**Daniel Building Renovation for:
Midwestern State University
Wichita Falls, Texas**

BYSP PROJECT NO. 18071

September 24, 2020

TO: All Contract Bidders of Record

1 ENLARGED UNDER FLOOR PLUMBING PLAN
SCALE: 1/4"=1'-0"

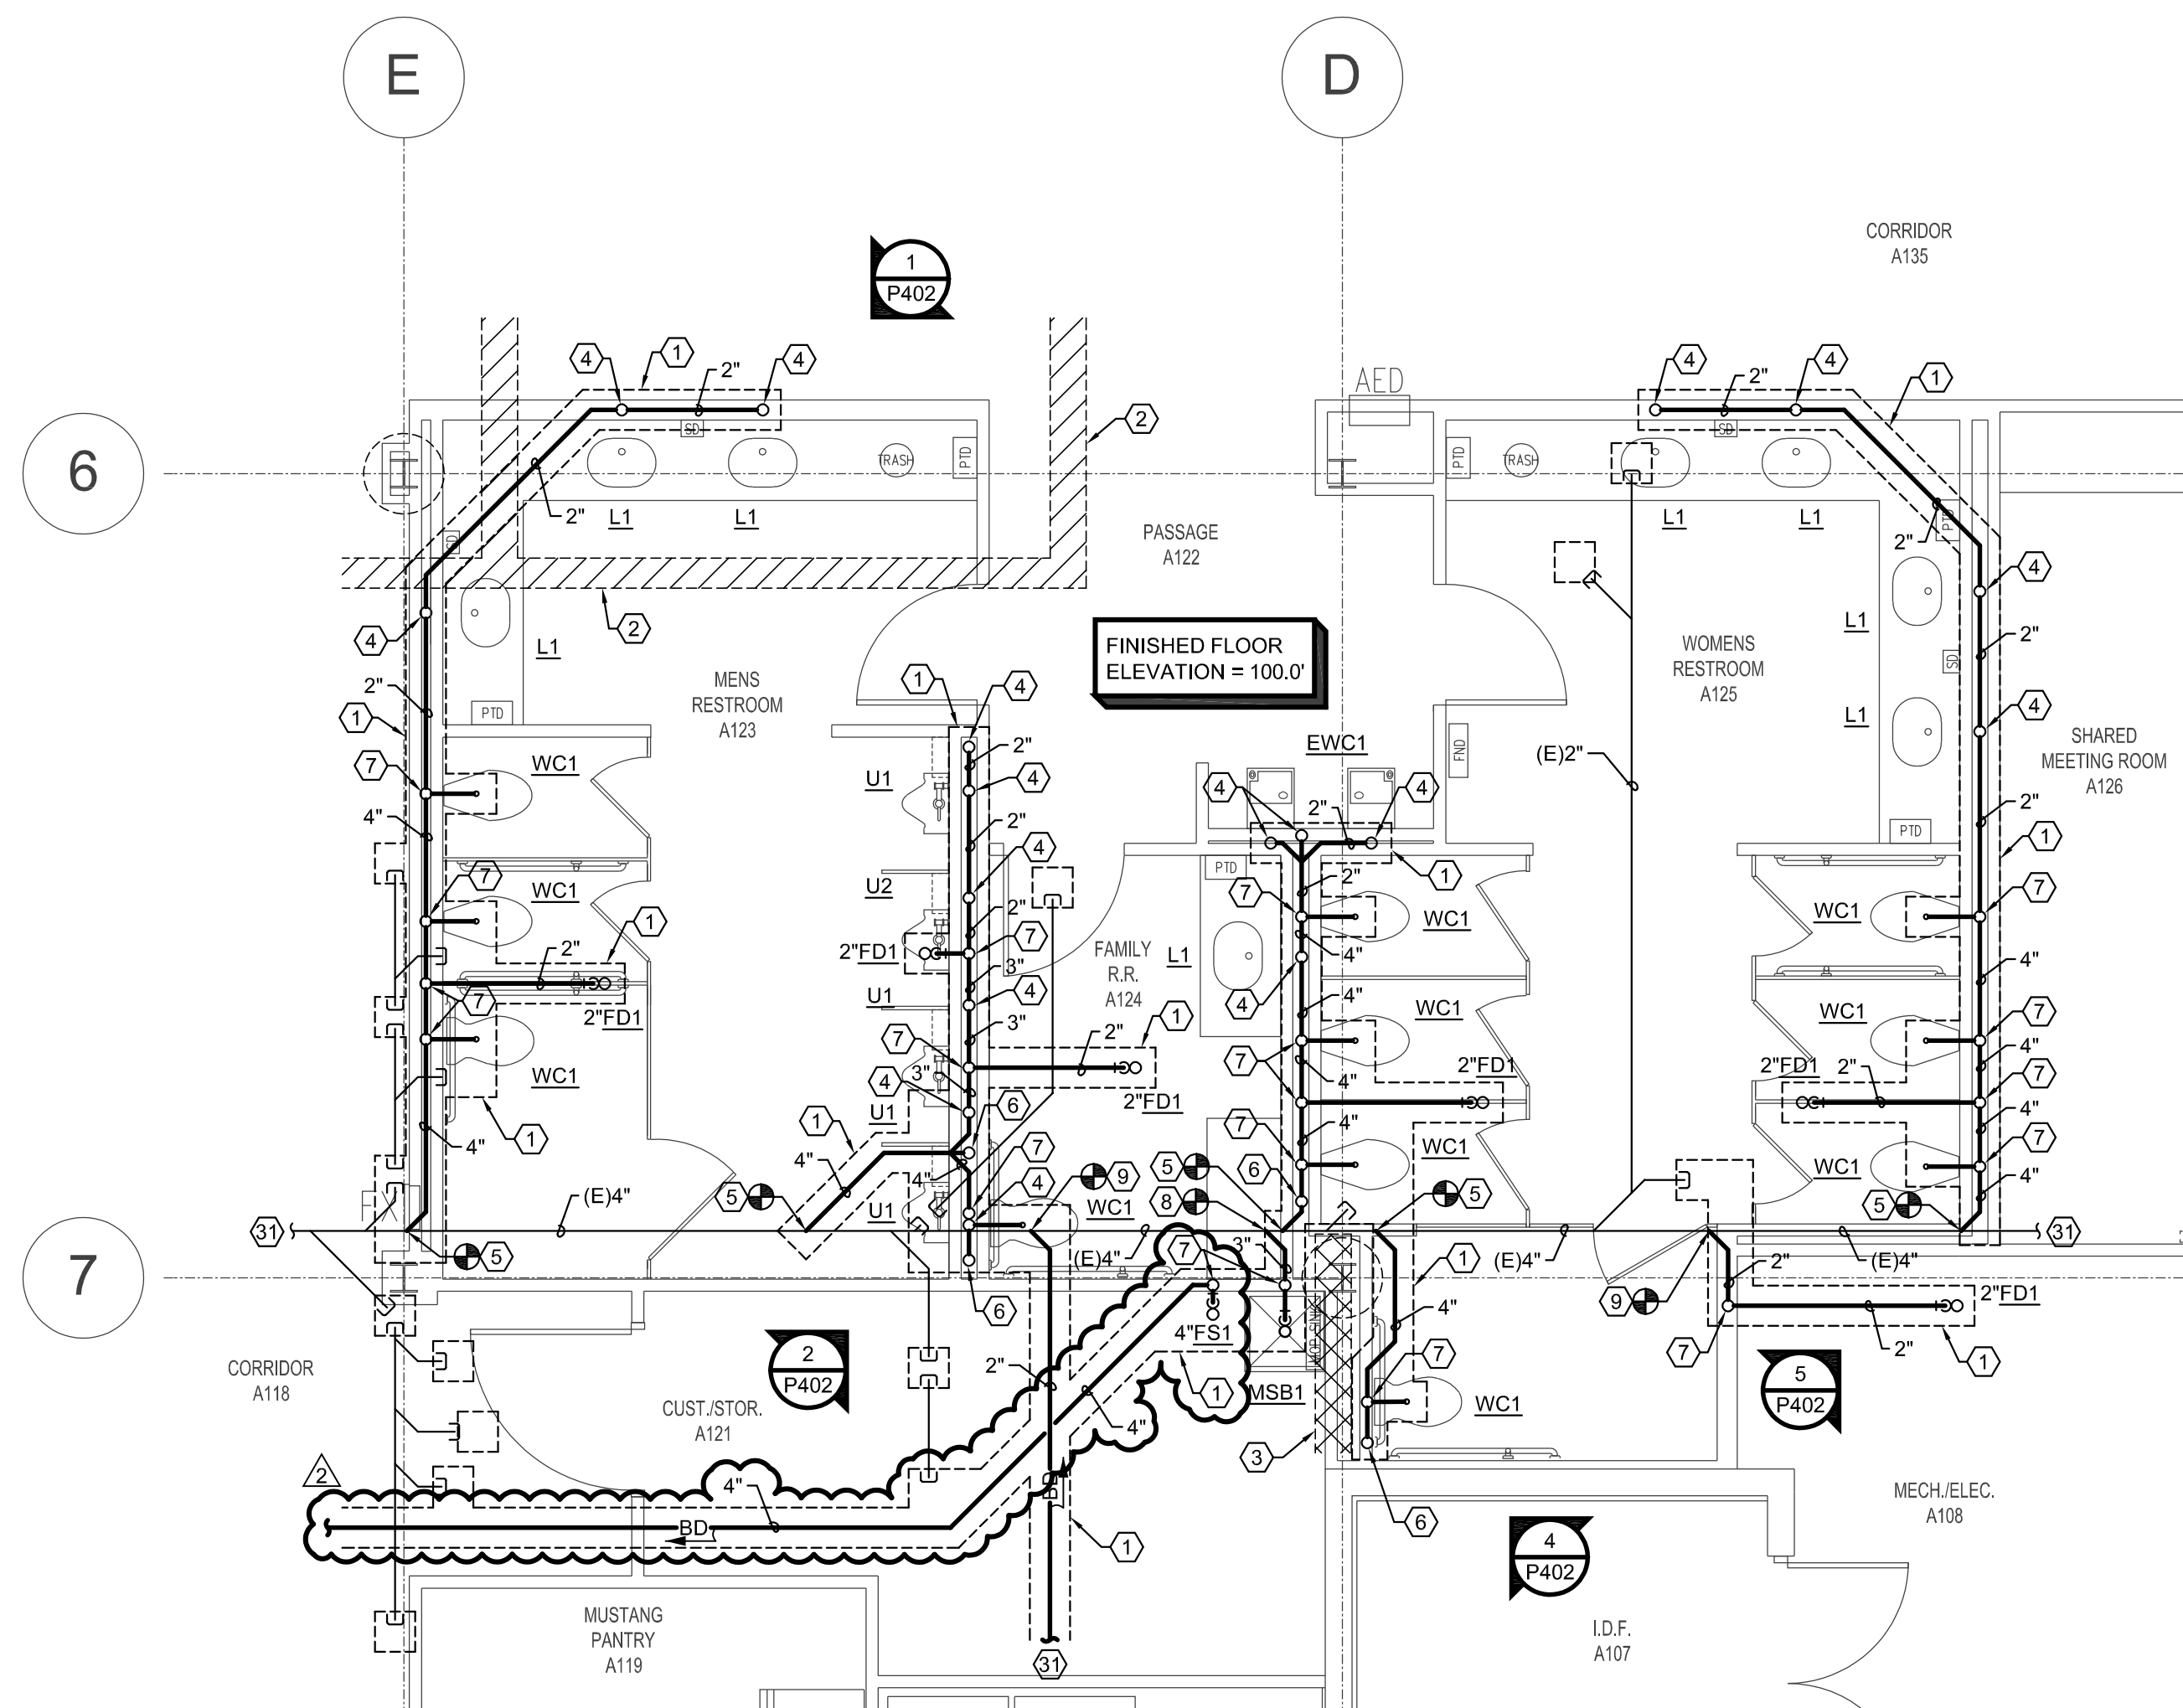
1. 1/P301 Enlarged Under Floor Plumbing Plan: Added new Floor Sink (FS1).
2. 1/P301 Enlarged Under Floor Plumbing Plan: Added new under floor sanitary sewer from new Floor Sink (FS1).
3. 3/P301 Enlarged Plumbing Plan: Removed Sump Pump Discharge Piping from Contract Documents.
4. 3/P301 Enlarged Plumbing Plan: Added new Floor Sink (FS1) and Associated Sanitary Sewer Vent Piping to Contract Documents.
5. Notes By Symbol: Changed note 26 to "Not Used."

3
P501
ELEVATOR SHAFT SUMP/SUMP PUMP DETAIL
NO SCALE

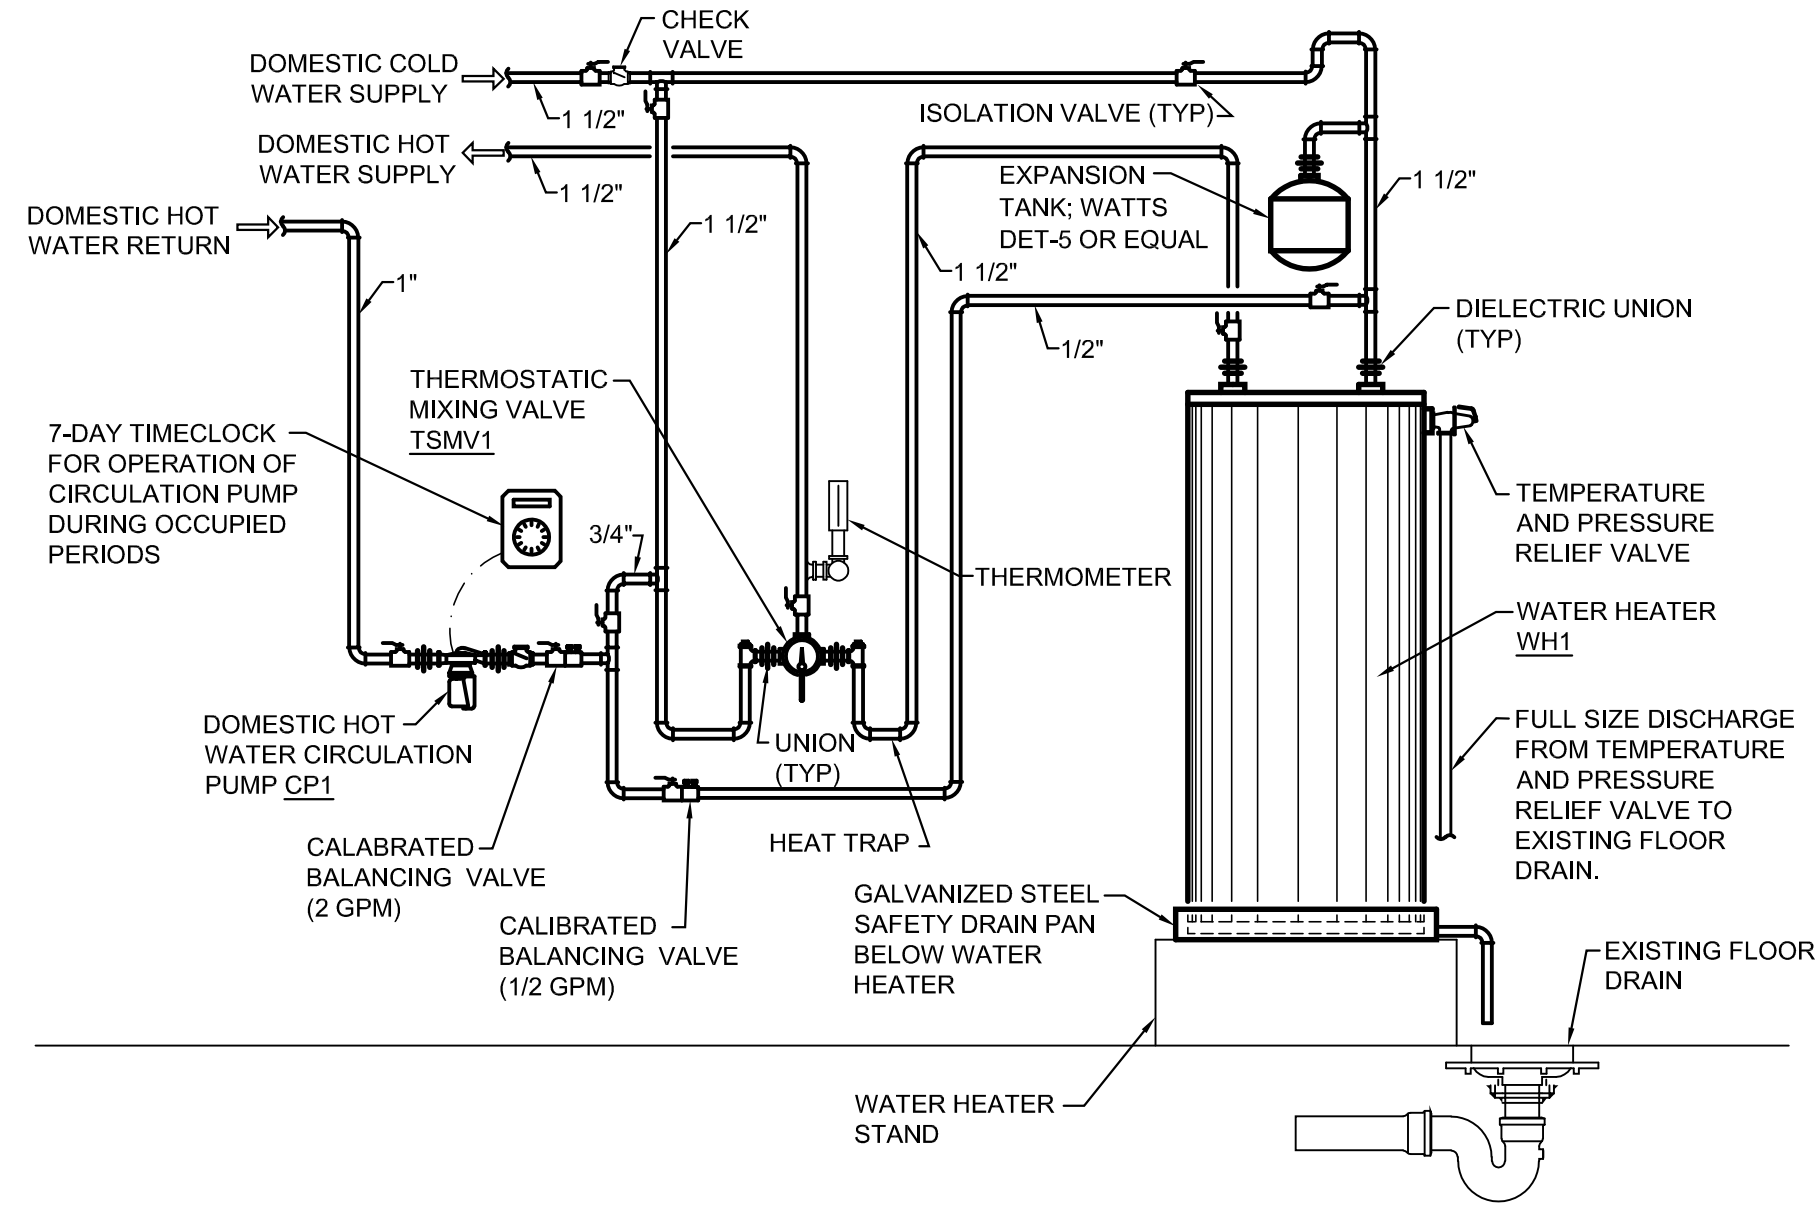
1. 3/P501 Elevator Shaft Sump/Sump Pump Details: Change Detail to “Not Used.”

23. Detail 3/P501 shows an alarm panel for an elevator sump water level alarm system.

Response: A Sump Pump is not to be installed in this Phase of construction, a Alarm System will not be required. However, if a Sump Pump is installed in a future phase it will be required.

1 FIRST FLOOR POWER PLAN
 SCALE: 1/8" = 1'-0"
 8 0 8 16

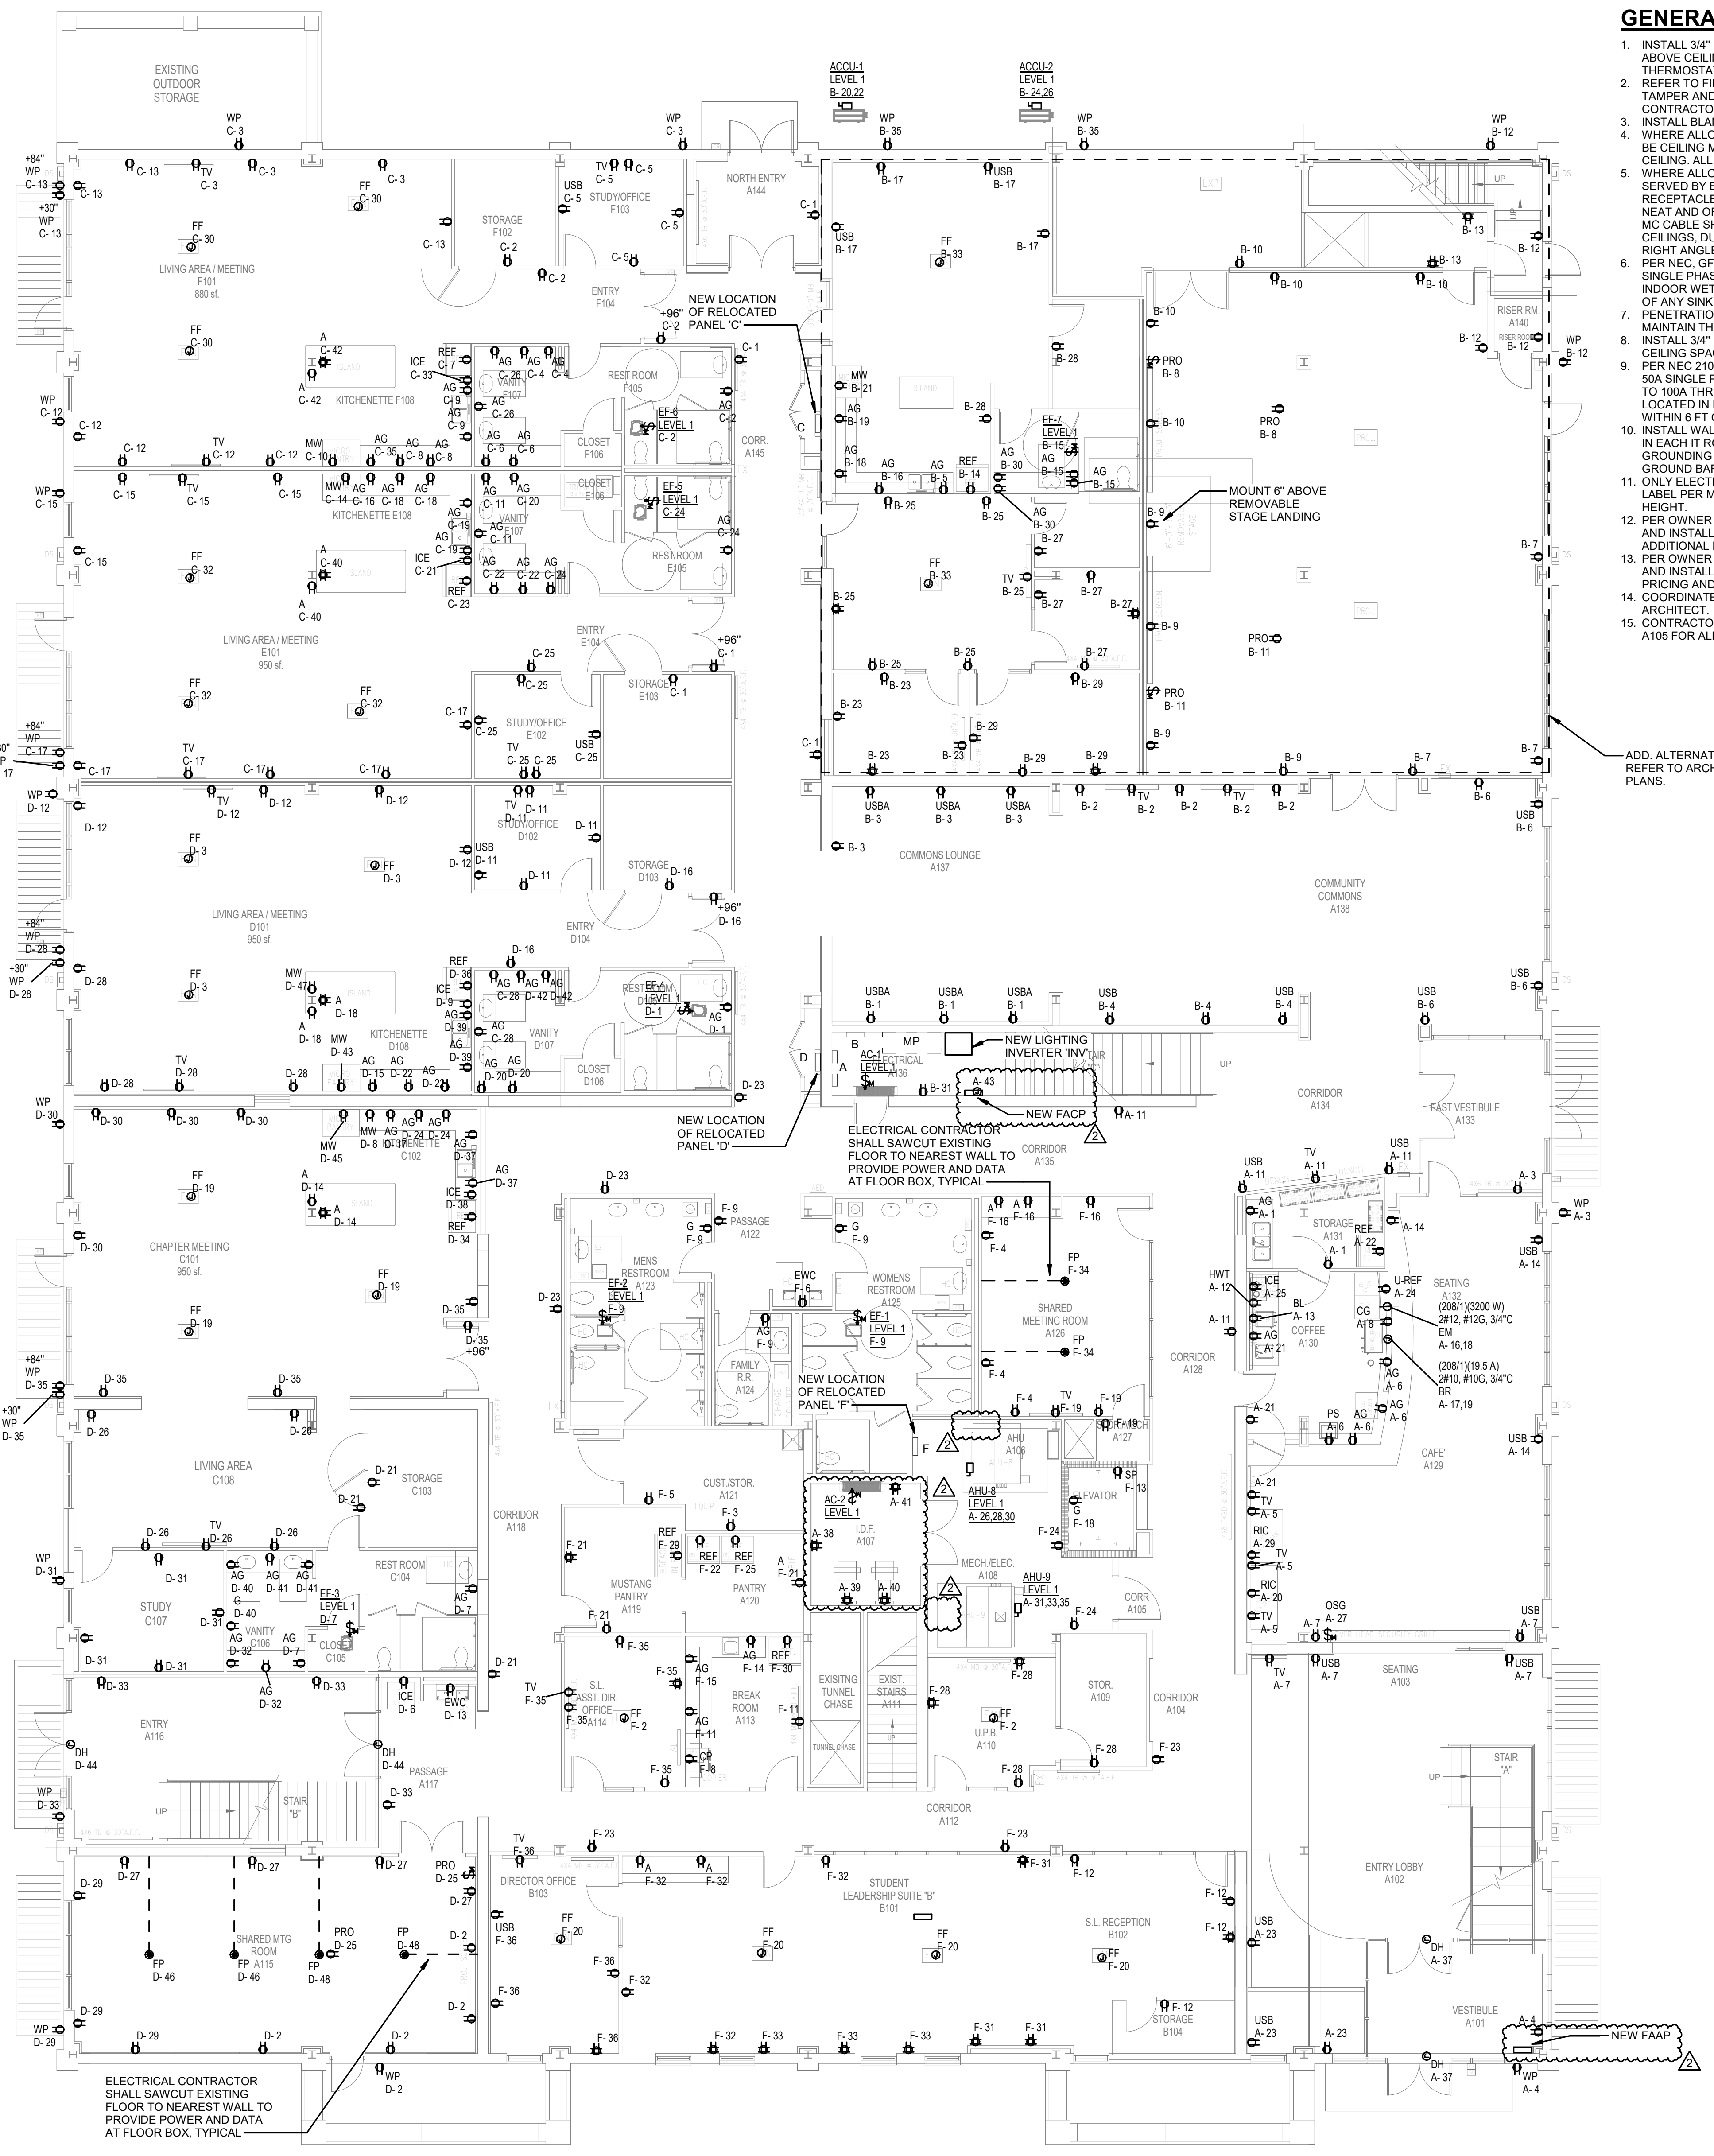
1. Fire alarm control panel in Vestibule A101 replaced with fire alarm annunciator panel. Fire alarm control panel relocated to Electrical A136.
2. Receptacles removed in Mech/Elec A108.
3. Circuits revised in IDF A107.
4. Sump pump receptacle and circuit wiring removed per plumbing revisions. Breaker shall remain in place and be labeled ‘Future Sump Pump’.
